Proposed update to BIP-8 mechanism

D2.1 Comment 270

Stephen J. Trowbridge
Alcatel-Lucent

Proposed Remedy

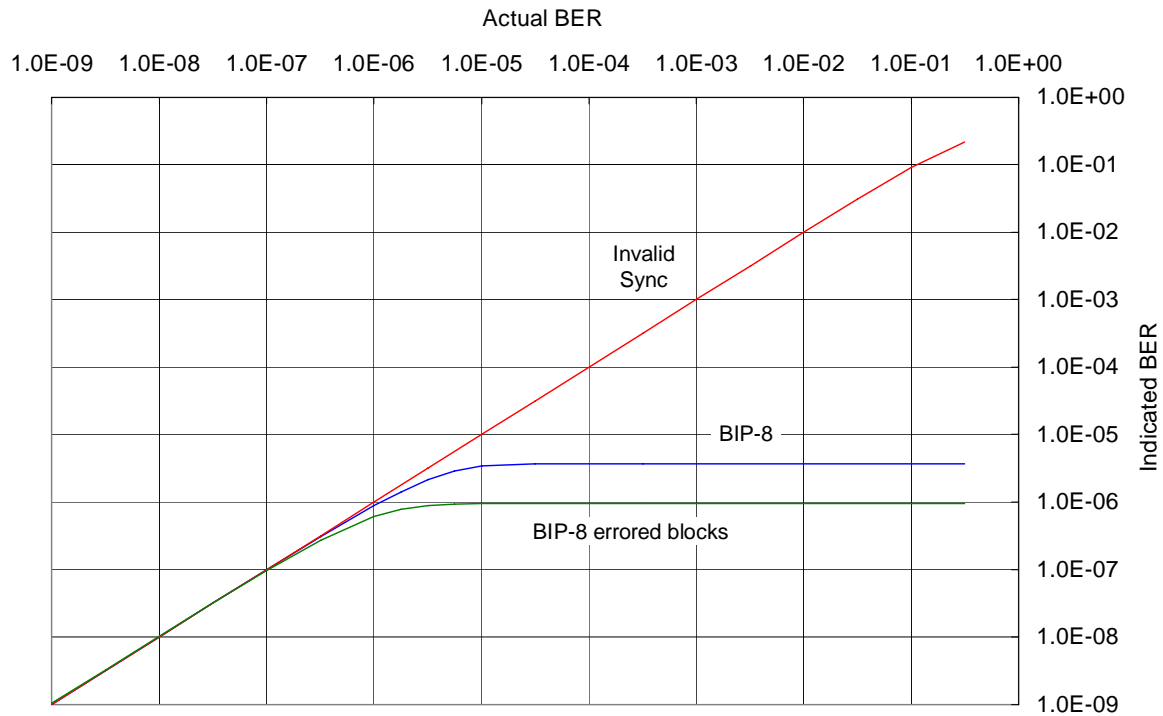
- Count errors like OTN or SDH/SONET B1 (count one error for each incorrect BIP-8 value)
- Generally will give the same error count even when bit errors hit the SH or control block type between the Ethernet Tx and OTN ingress (missing only 1/256 of the cases where by accident the error control block makes a good BIP)
- Saturates a factor of 4 lower (green line added to chart from nicholl_01_0109), but the mechanism is being used to verify 10^{-12} , not 10^{-5} or 10^{-6} . Within the range of interest, the count is the same

“As part of the alignment marker removal process, the BIP3 field is compared to the calculated BIP value for each PCS lane. If a Clause 45 MDIO is implemented, then the appropriate BIP error counter register is incremented for each 8-bit BIP value in error (registers 3.90 through 3.99).”
